Groundwater Application Review Summary Form

Application # G- 19047

TO: Water Rights Section Date 8/25/2023
 FROM: Groundwater Section Halley Schibel/Travis Brown/Stacey Garrison
 Reviewer's Name
 SUBJECT: Application G- 19047 Supersedes review of _____
 Date of Review(s)

A. GENERAL INFORMATION: Applicant's Name: Graymont Western US Inc. c/o Rob Freeman
 County: Marion

Hydrographs – All Nearby Observation Wells, All Measurements

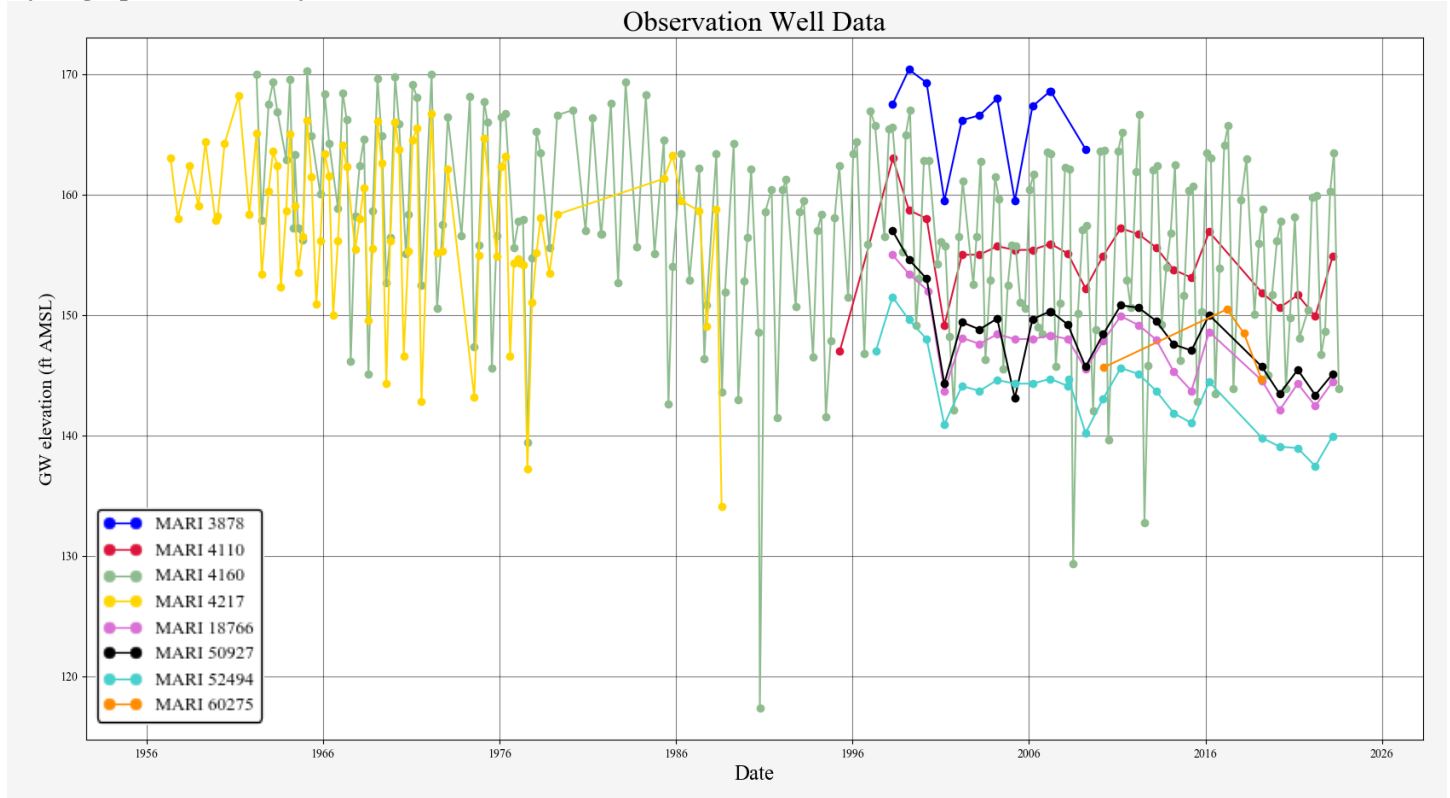
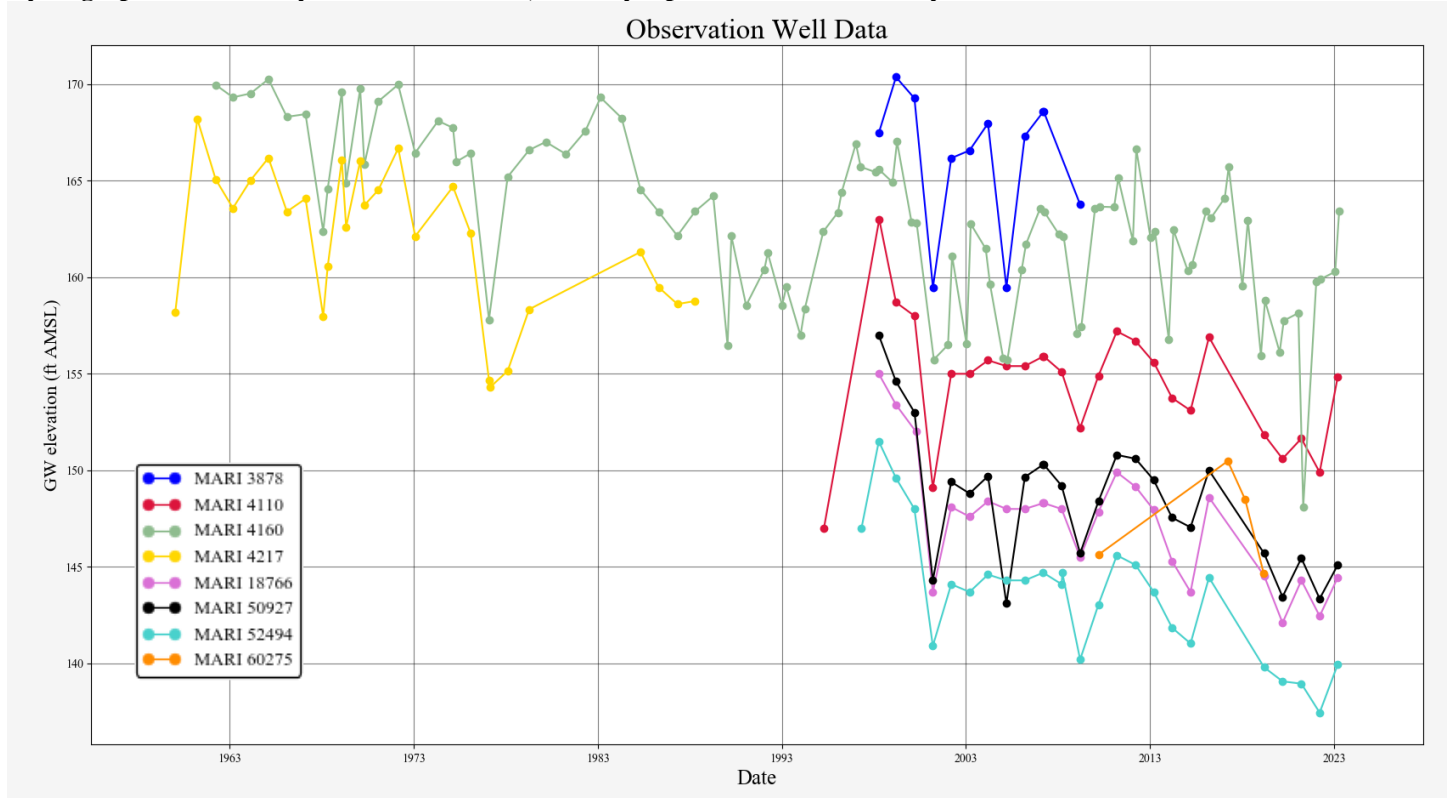
Nearby observation wells include state observation wells MARI 4160 and MARI 4217 with static water level measurements on record since the late 1950’s/early 1960’s, with MARI 5217 being dropped from the network in the late 1980’s. Other nearby wells include wells on permits with static water level reporting conditions, which have measurements on record since the late 1990’s. Neither the permit condition wells nor the longer-term state observation well data show excessive, area-wide declines. Static water levels appear to be slightly deeper in the deeper wells that go into the Willamette Confining Unit. Within 1 mile of the proposed POA, there are 40 POAs associated with 47 water rights and a majority of these are for irrigation; although this is a high density of groundwater use, the long-term steady trend in the observation wells indicates the groundwater resource is not over-appropriated.

Hunt (2003) Model Parameters and Output

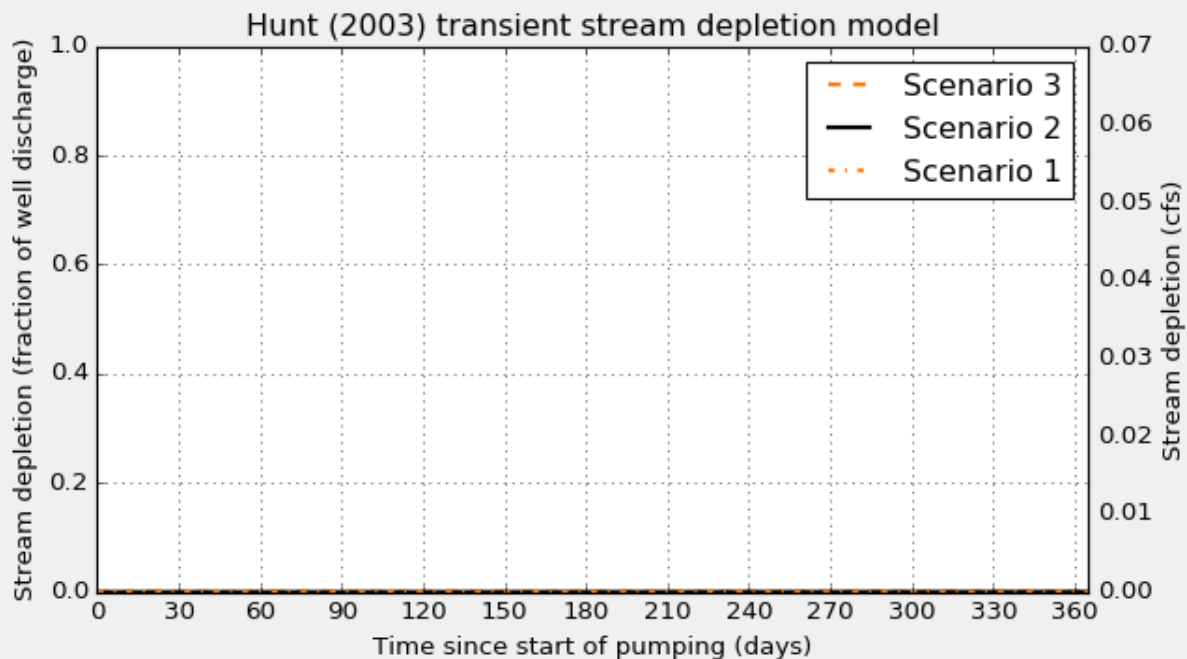
Basis for impact evaluation: The low pumping rate and great distance between the proposed well and Patterson Creek combined with existing knowledge of the hydrogeologic regime in this area indicate that it is unlikely for the well to cause substantial interference. Potential for substantial interference was checked against the quantitative Hunt (2003) model using hydraulic parameters derived from regional data and studies (Pumping test reports; Conlon et al., 2005; Domenico and Schwartz, 1990; Freeze and Cherry, 1979; Iverson, 2002; Lohman, 1972; Price, 1967; Todd, 1980; and Woodward, 1998). Results indicate that interference with SW 1 is not anticipated to exceed 25 percent of the rate of withdrawal within the first year of continuous pumping.
